SUBJECT: NEW VEHICLE DEMONSTRATION / DELIVERY HOLD - Safety Recall 19S31
Certain 2019 Model Year F-Super Duty Vehicles
Passenger Side Rear Axle Shaft Inspection

NEW VEHICLE DEMONSTRATION / DELIVERY HOLD - Safety Recall 19S31

CERTAIN 2019 MODEL YEAR F-SUPER DUTY VEHICLES — PASSENGER SIDE REAR AXLE SHAFT INSPECTION

FIGURE 1

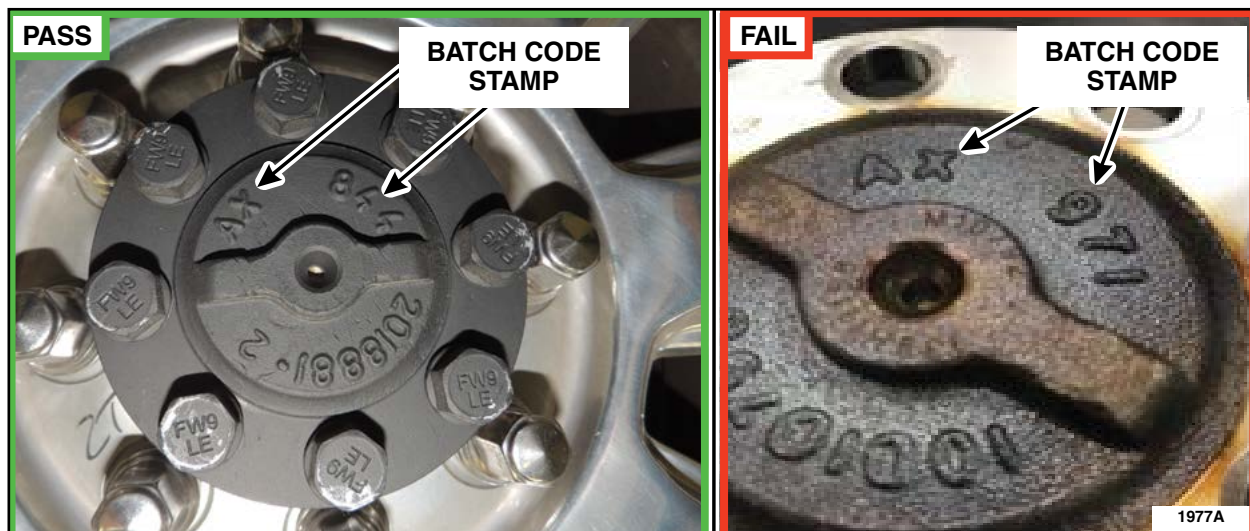
1. Remove the passenger side rear wheel center cap (if equipped).
2. Inspect the batch code stamp located on the passenger side rear axle shaft flange.
See Figure 1.

- Is the batch code stamp AX 971?

Yes - The passenger side rear axle shaft requires replacement. Proceed to Step 3.

No - No further action is required, the safety recall is complete.

FIGURE 2

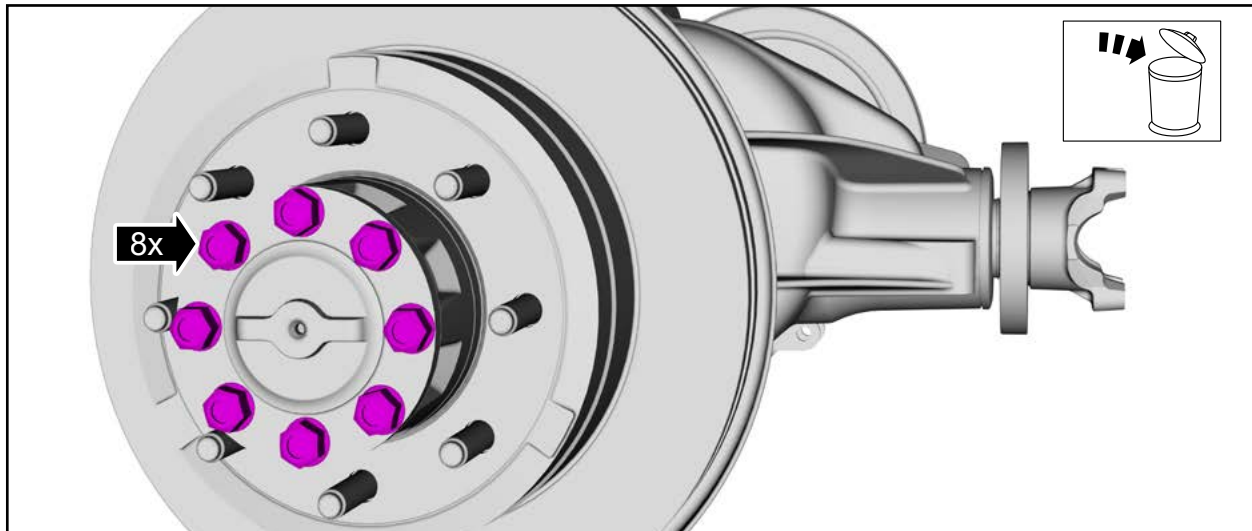
4. Remove and discard the passenger side rear axle shaft bolts. See Figure 2.

8. Install the *new* axle shaft into the passenger side rear axle housing. See Figure 3.
9. Install the *new* axle shaft bolts finger tight. See Figure 2.
10. Lower vehicle from the hoist and set the parking brake or chock the wheels.
11. Torque the passenger side rear axle shaft bolts in a cross pattern.
 - Torque 188 lb.ft (255 Nm)
12. Release the parking brake / remove the wheel chocks.
13. Check and top off the differential fluid. Please follow the WSM procedures in Section 205-02A.
14. Reinstall the passenger side rear wheel center cap (if equipped).

FIGURE 3

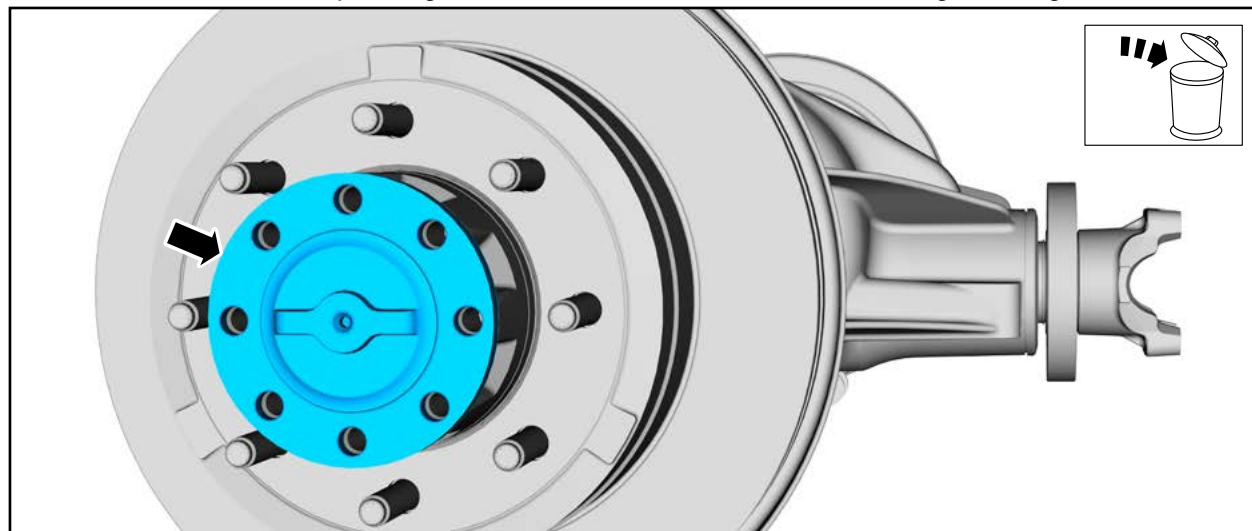
5. Remove and discard the passenger side rear axle shaft and axle shaft O-ring. See Figure 3.

FIGURE 4

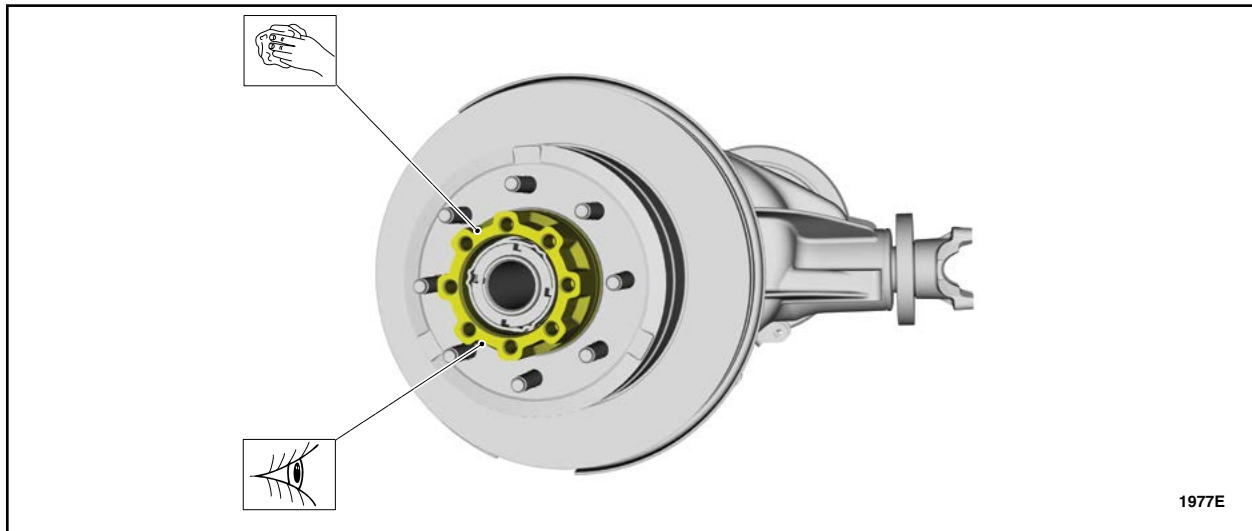
6. Clean and inspect the hub-to-axle shaft mating surface. See Figure 4.

FIGURE 5

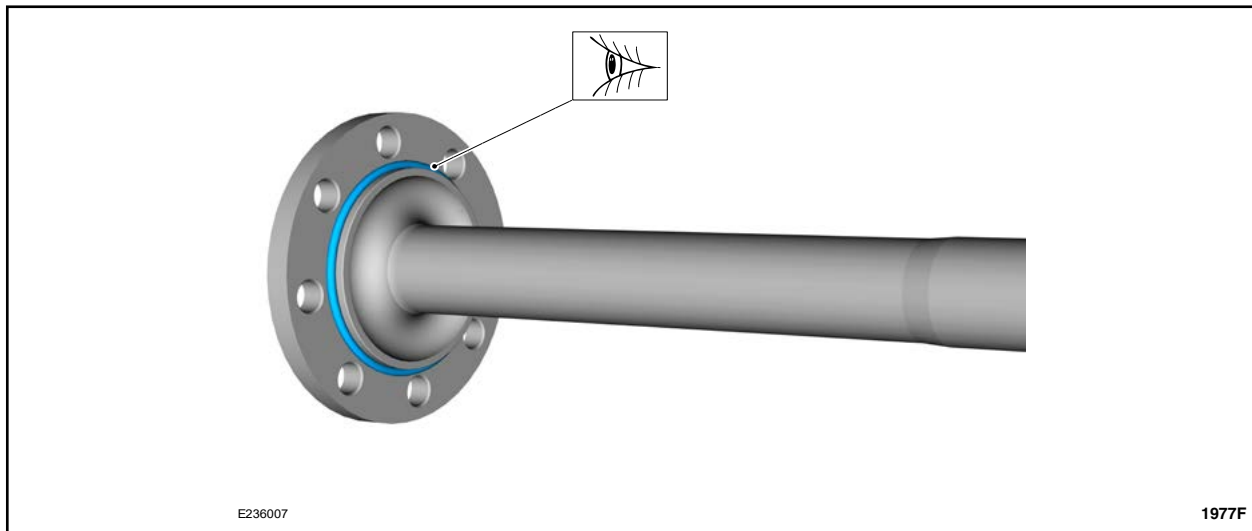
7. Install a *new* O-ring on the *new* axle shaft. See Figure 5.
